**Planning Commission  
Staff Report**

April 23, 2014  
Item 5.b.

**SUBJECT:** PUD-85-02-02D-06M

**PURPOSE:** Application for PUD Major Modification to the existing PUD Development Plan (PUD-85-02-02D) for: (1) the phased demolition of all existing buildings; and (2) the construction and operation of an approximately 83,300-square-foot automobile showroom and service facility for Lexus of Pleasanton.

**FIGURE 3:** Proposed Landscaping Plan

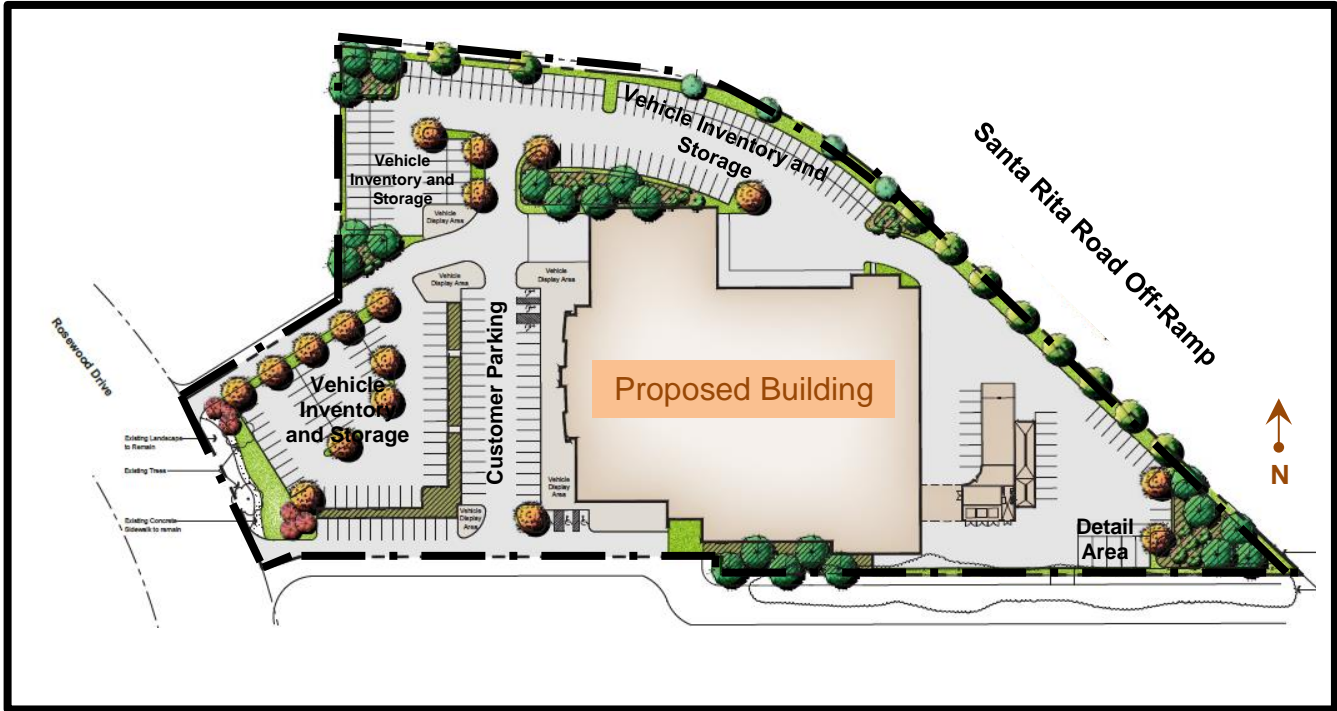
A condition of approval also requires that trees be incorporated in the landscaping area adjacent to and in vicinity to the customer parking area (where there are currently no trees shown). Since no landscaping is proposed adjacent to the showroom and service building, a condition of approval requires landscaping in planter boxes and/or pots be provided in

this area. Finally, another condition requires that a more drought-tolerant species than the River Burch, and a more frost-resistant shrub than the proposed Bottlebrush be incorporated into the final landscaping plans included with plan check plans.

**FIGURE 7:** Aerial photograph identifying required traffic improvement to northbound left turn lane at Santa Rita Road and Rosewood Drive

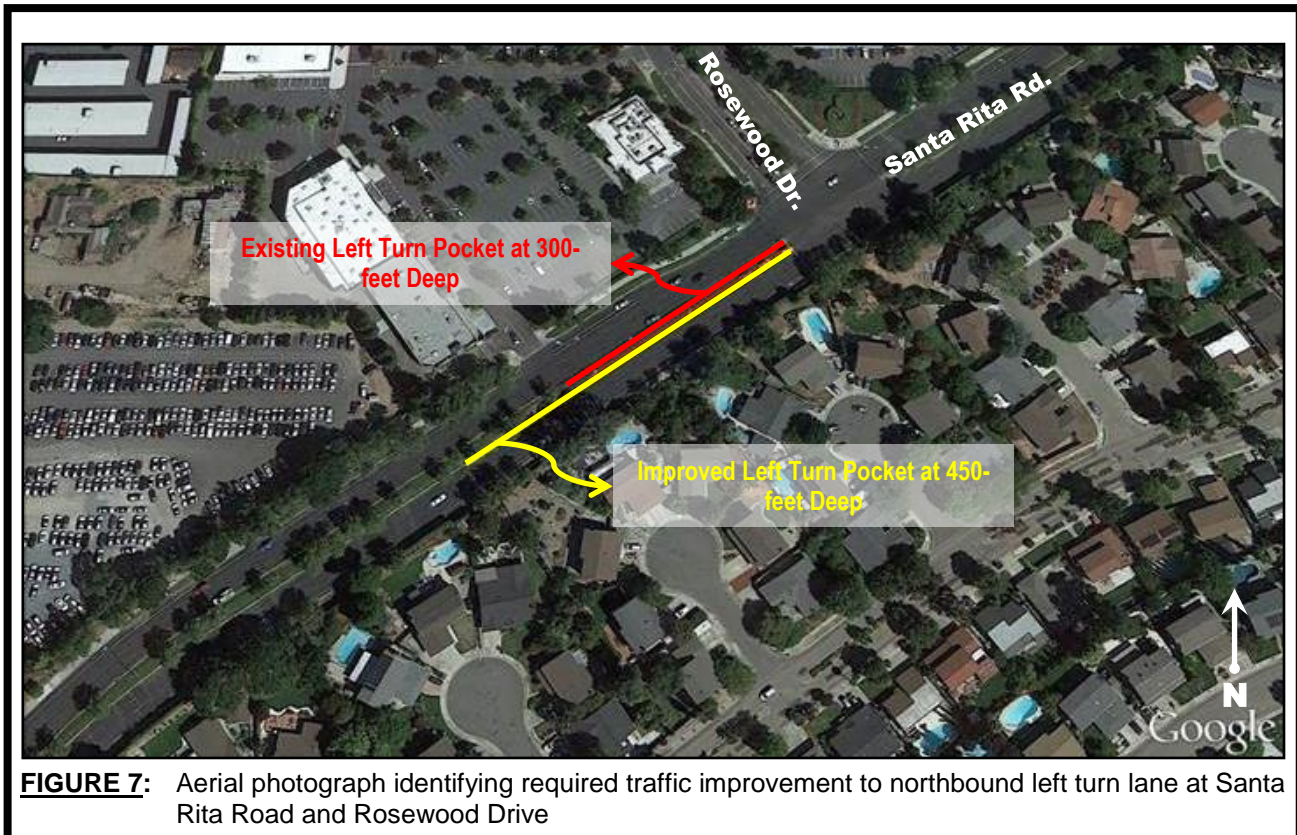
The City Traffic Engineer has not required a traffic report for the subject project, but has identified an improvement that the applicant would have to construct to the north-bound left turn lane at the intersection of Santa Rita Road and Rosewood Drive. This left-turn lane would be required to be extended by approximately 150 feet, from the existing 300-foot depth to approximately 450-foot deep (please reference Figure 7). Construction of the improvement results in the loss of 6 to 7 trees within the existing median. A condition of approval requires this improvement to be constructed prior to Certificate of Occupancy of the final phase of construction.

The improvement identified in Figure 7 is not identified as project in the Pleasanton Traffic Impact Fee (T.I.F.), but the City Traffic Engineer expects that this improvement will be identified in the next T.I.F. update and recommends the cost of this improvement be credited towards the project's T.I.F. fees. The project's construction of the improvement and payment of T.I.F. will mitigate its increase in traffic and help pay for mitigations already identified in the traffic impact fee report and General Plan.
